**SECTION 00 9111  
ADDENDUM NUMBER 1**

- 1.01 DATE: AUGUST 29, 2014
- 1.02 PROJECT: UNIVERSITY OF SOUTH CAROLINA - SOM BUILDING #1 SECOND FLOOR AHU REPLACEMENT
- 1.03 PROJECT NUMBER: STATE PROJECT #H27-Z160, A/E #14037.01
- 1.04 OWNER: UNIVERSITY OF SOUTH CAROLINA
- 1.05 ARCHITECT: GMK ASSOCIATES, INC.

sheet title  
**PARTIAL SECOND FLOOR PLAN -  
HVAC DEMOLITION AND  
RENOVATION**

**M2.2**

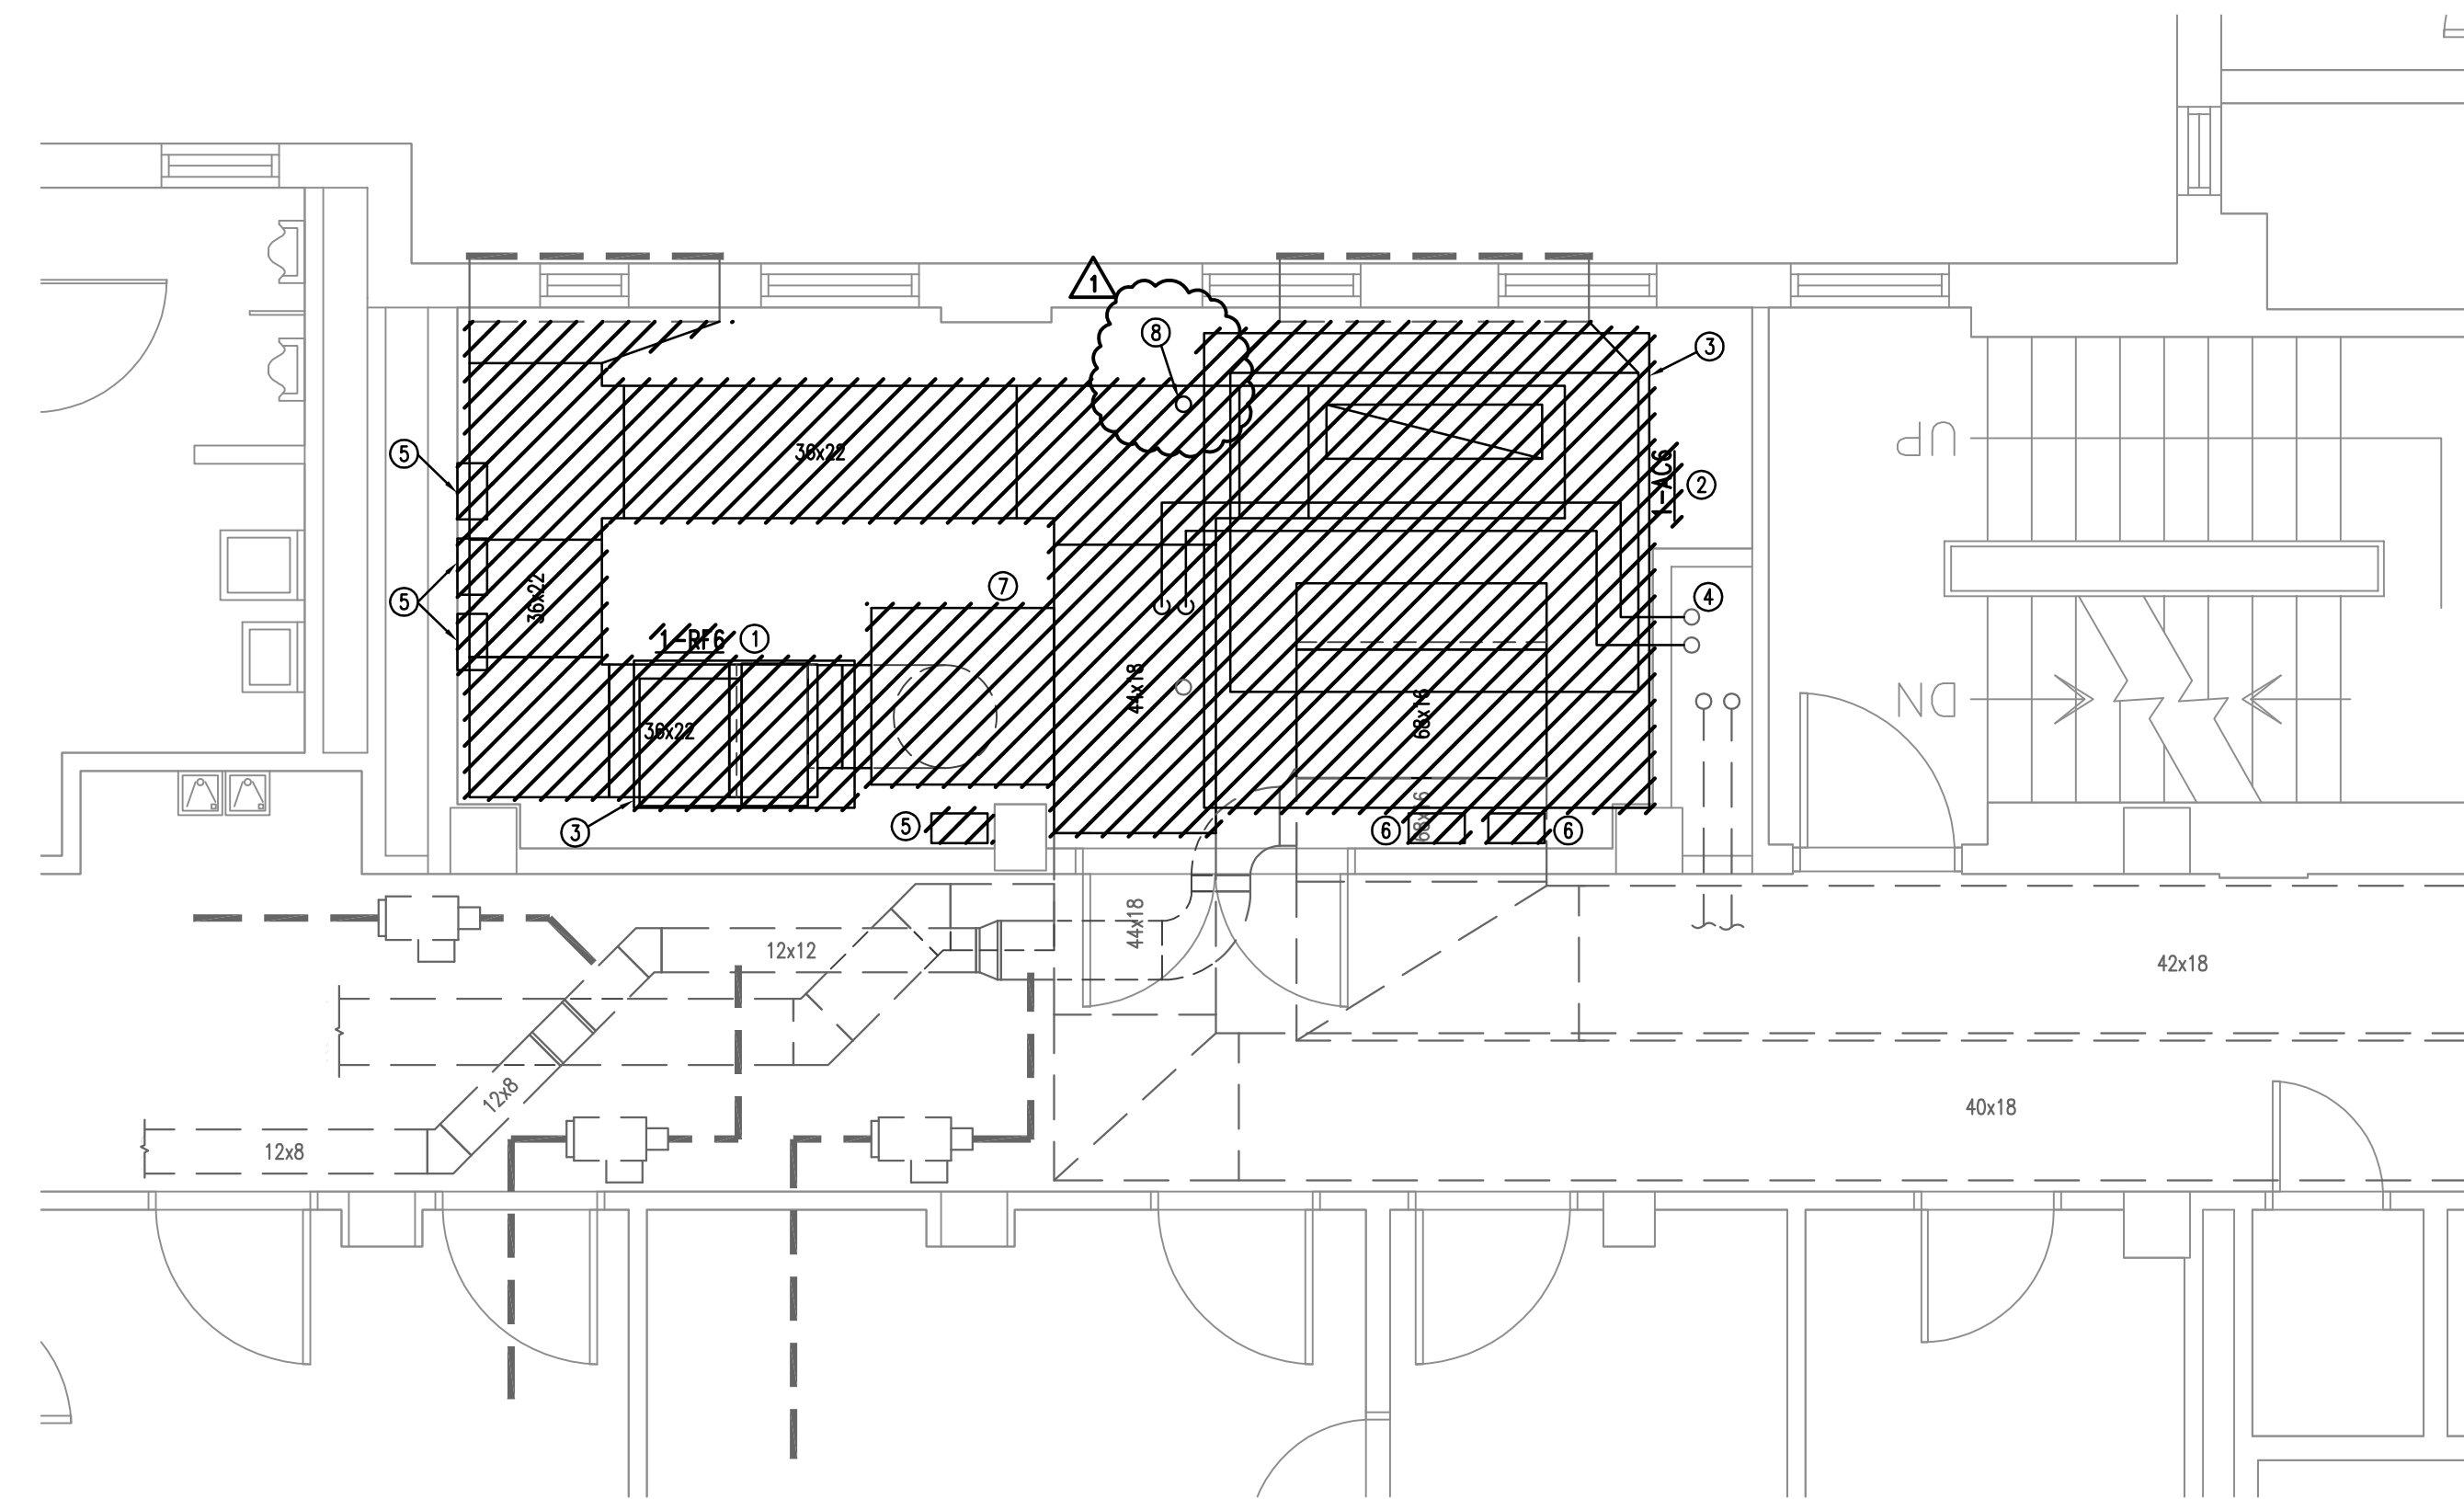
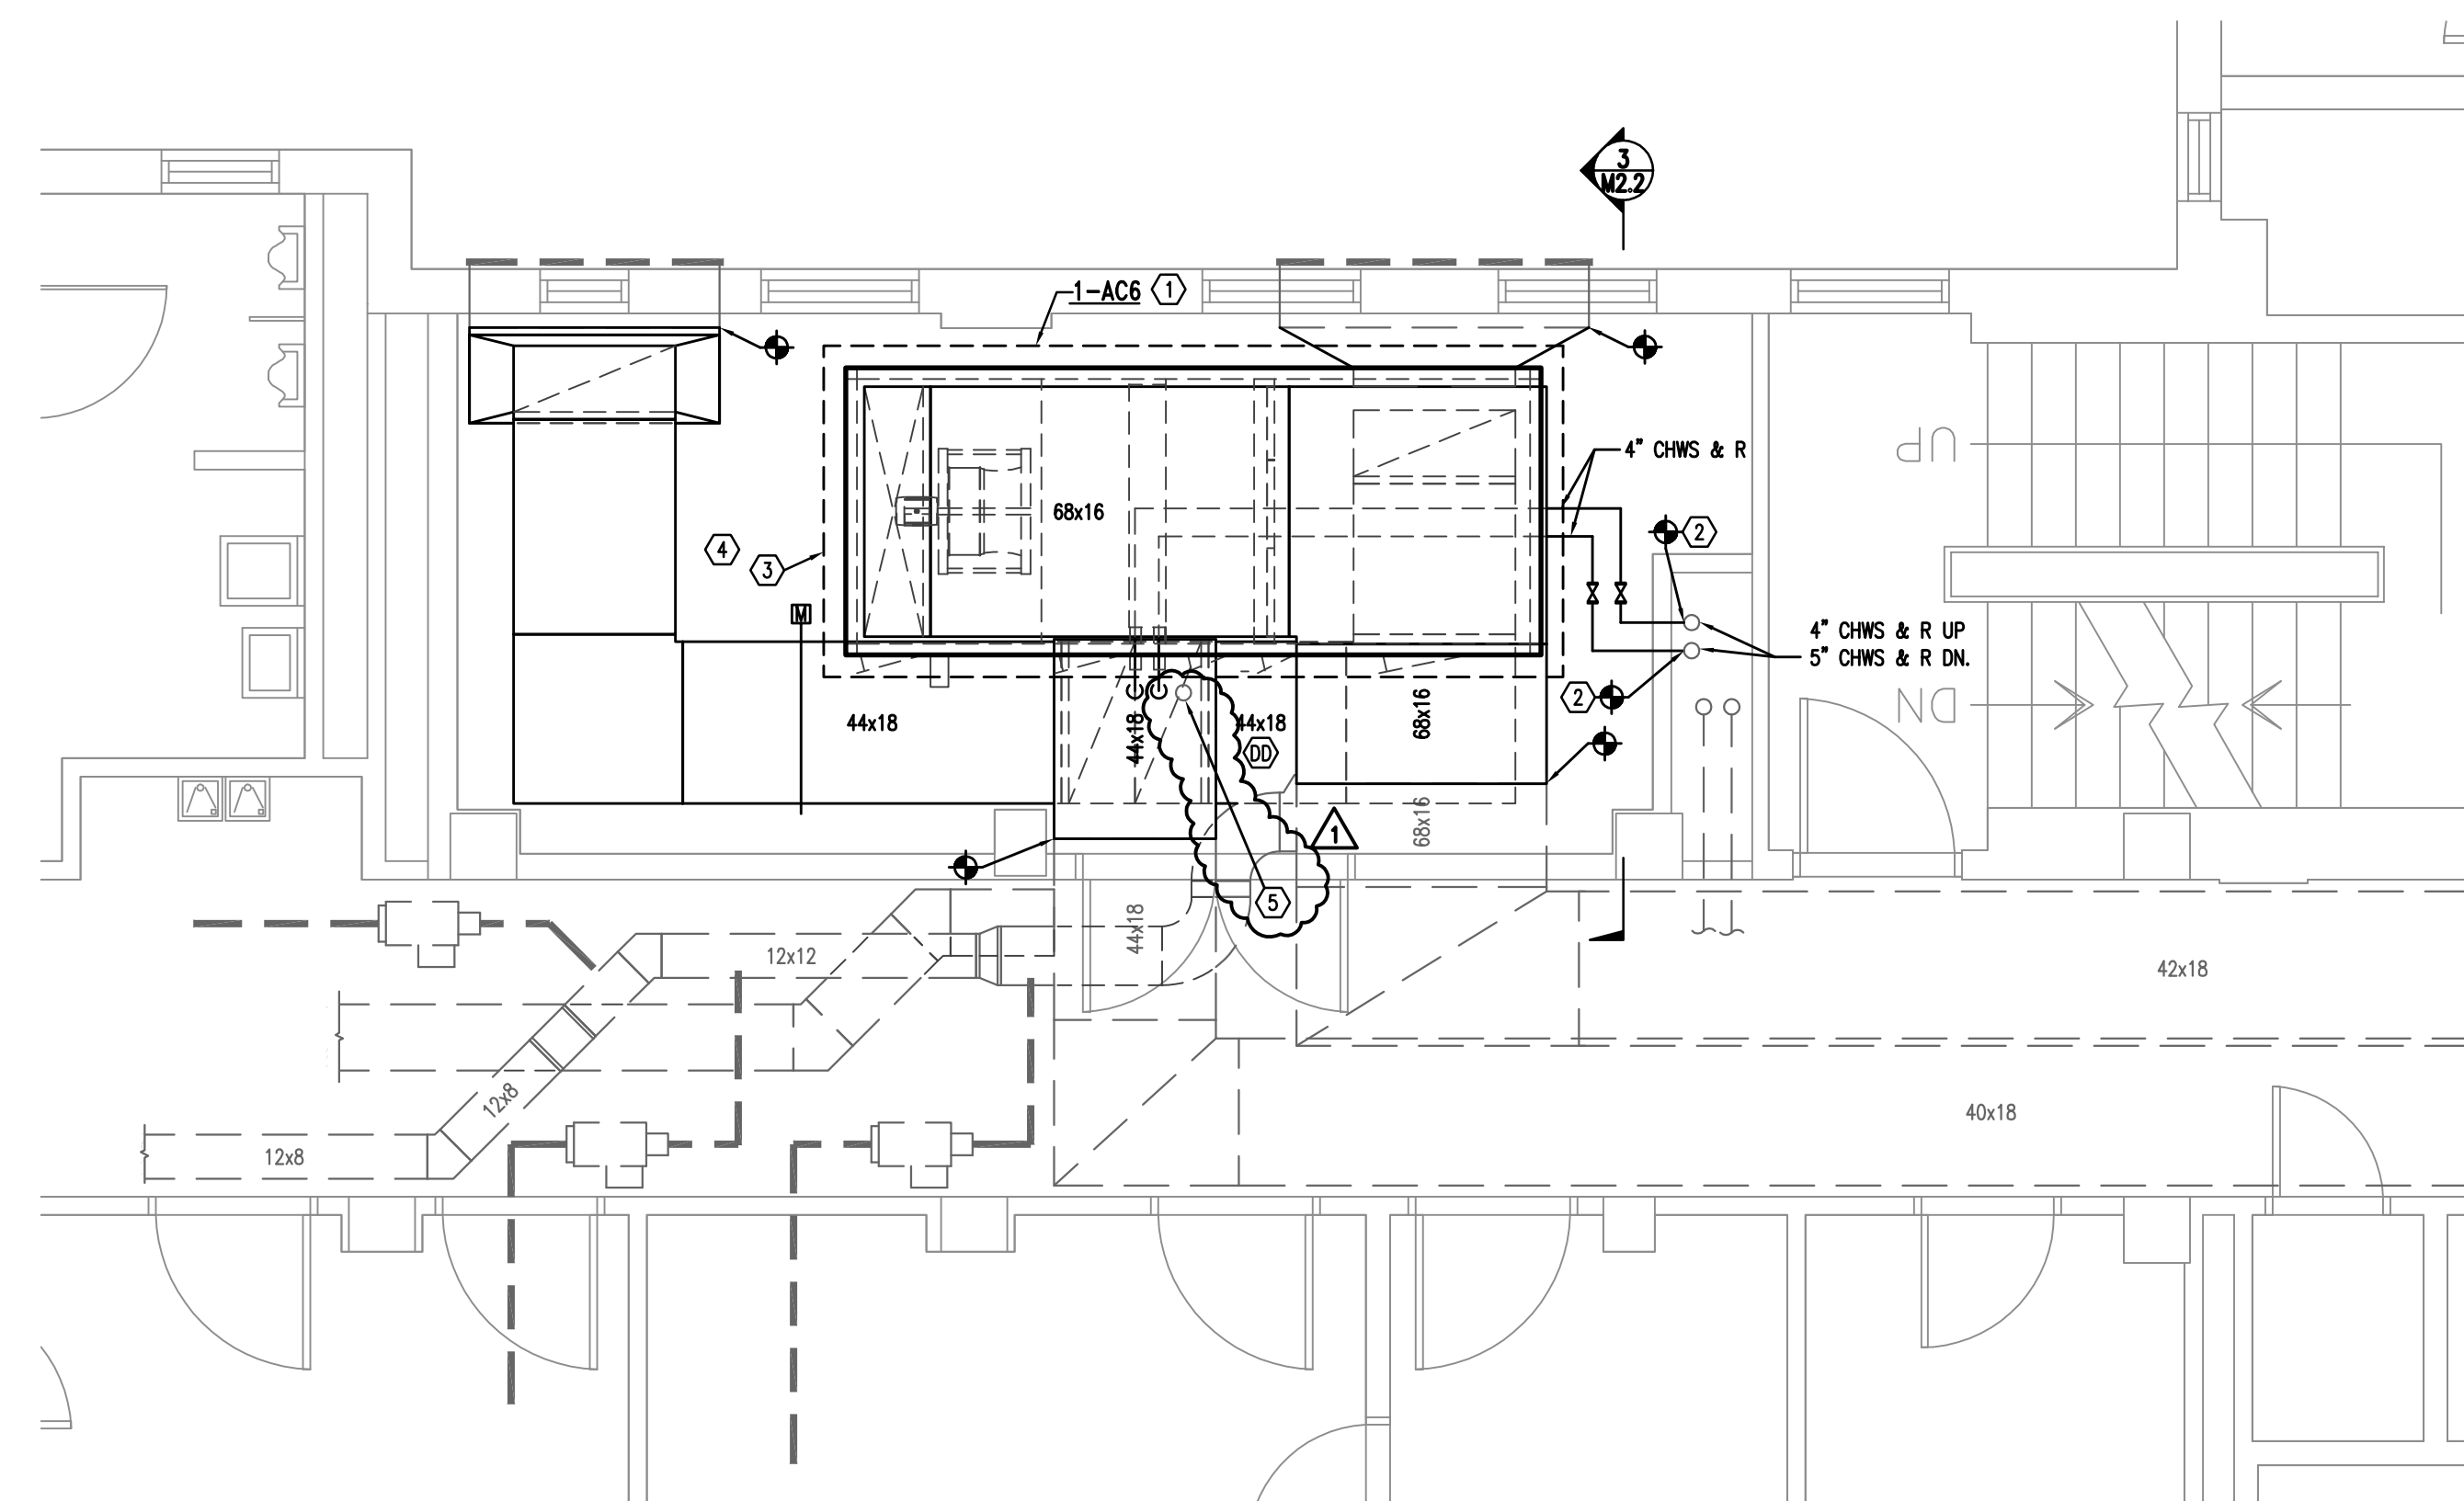
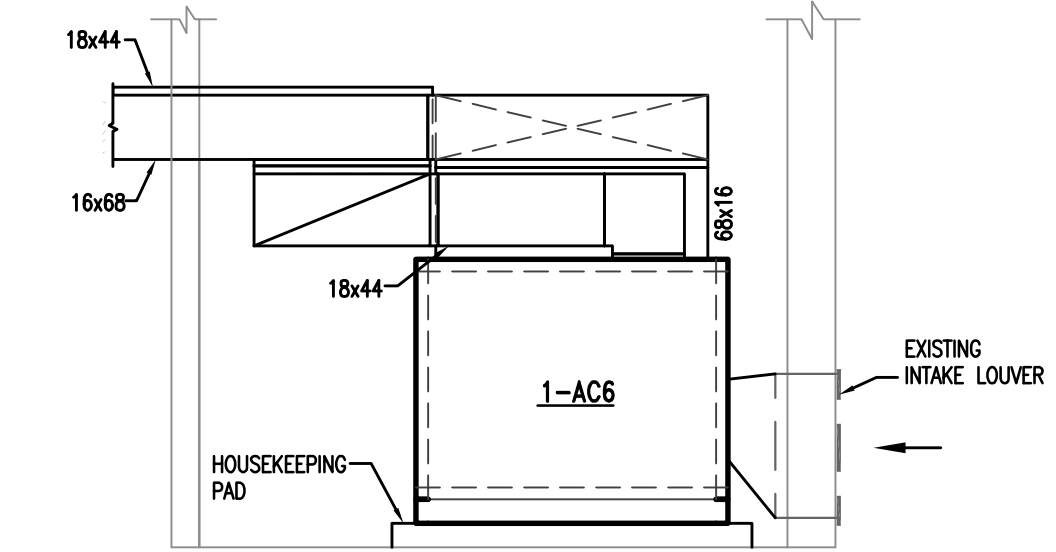
- 6.01 DRAWING M2.2
  - A. Replace sheet M2.2 in its entirety.
